DEVIATION REQUEST (Attach diagrams, figures, and other documentation to clarify request) (Date: 12/18/2023 Initial Submittal) This deviation request is for intersection spacing and a few other geometric/roadway design elements on **Windermere Court**. As such, this deviation includes several itemized parts/elements. Please refer to deviation exhibits 1 – 6b. Deviation Exhibit 1 shows the location of this street on the site plan map.

LSC Responses to Deviation Redline Comments

Deviation Requests

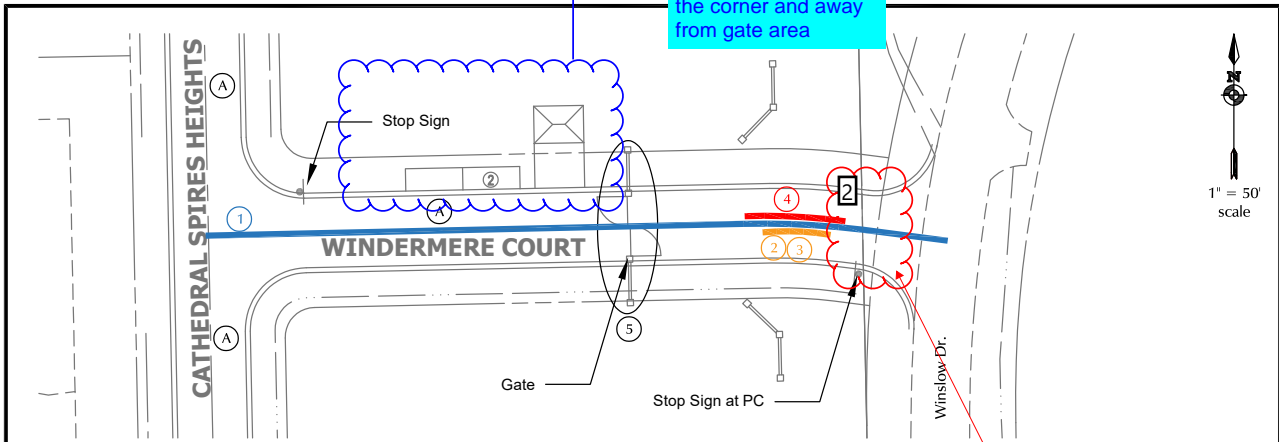
Consider low intensity lighting for gate area

Consider low intensity lighting for gate area

Author: Jeff Date: 3/28/2024 09:26:27
LSC Response: The applicant will consider.

**ACCESS CL PROFILE
 STA 1+00.00 TO 3+99.27**

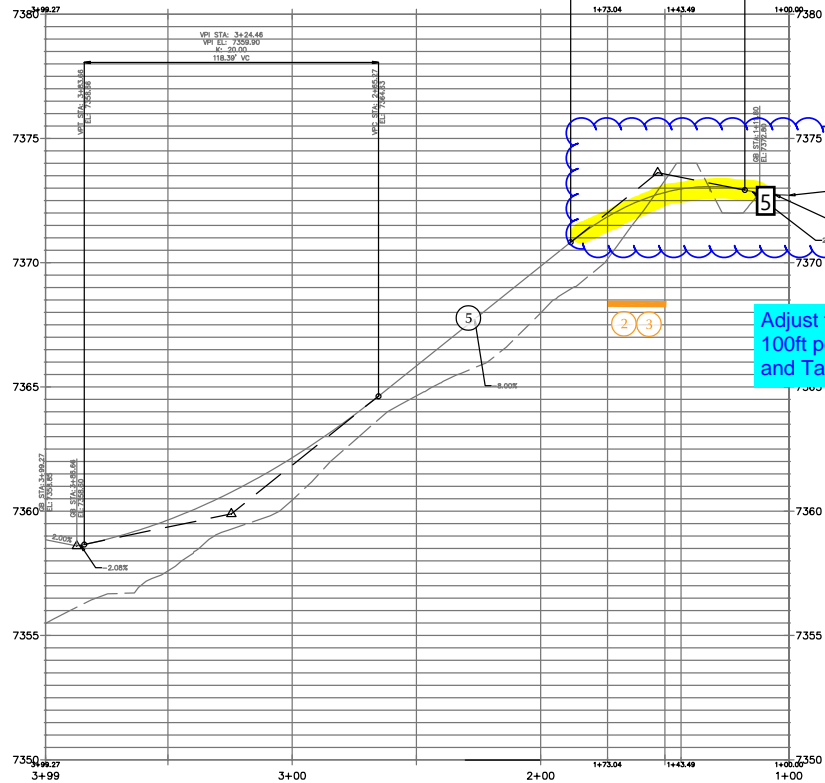
Adjust to 4% for first 100ft per Table 2.22 and Table 2.33

Adjust to 4% for first 100ft per Table 2.22 and Table 2.33

Author: Jeff Date: 3/29/2024 14:40:40

LSC Response: Updated as requested.

Note that the intersection grade and tangent per Tables 2.22 and Table 2.33 are not met and deviation is not recommended for the first 100ft from Winslow. Update the Deviation and road profile for Windmere Ct (name change TBD) Max 4% for first 100ft

It is recommended to move the mail kiosk and pull off around the corner and away from gate area

Note that the intersection grade and tangent per Tables 2.22 and Table 2.33 are not met and deviation is not recommended for the first 100ft from Winslow. Update the Deviation and road profile for Windmere Ct (name change TBD) Max 4% for first 100ft

LSC Response: This change has been made.

LSC Response: Updated as requested.
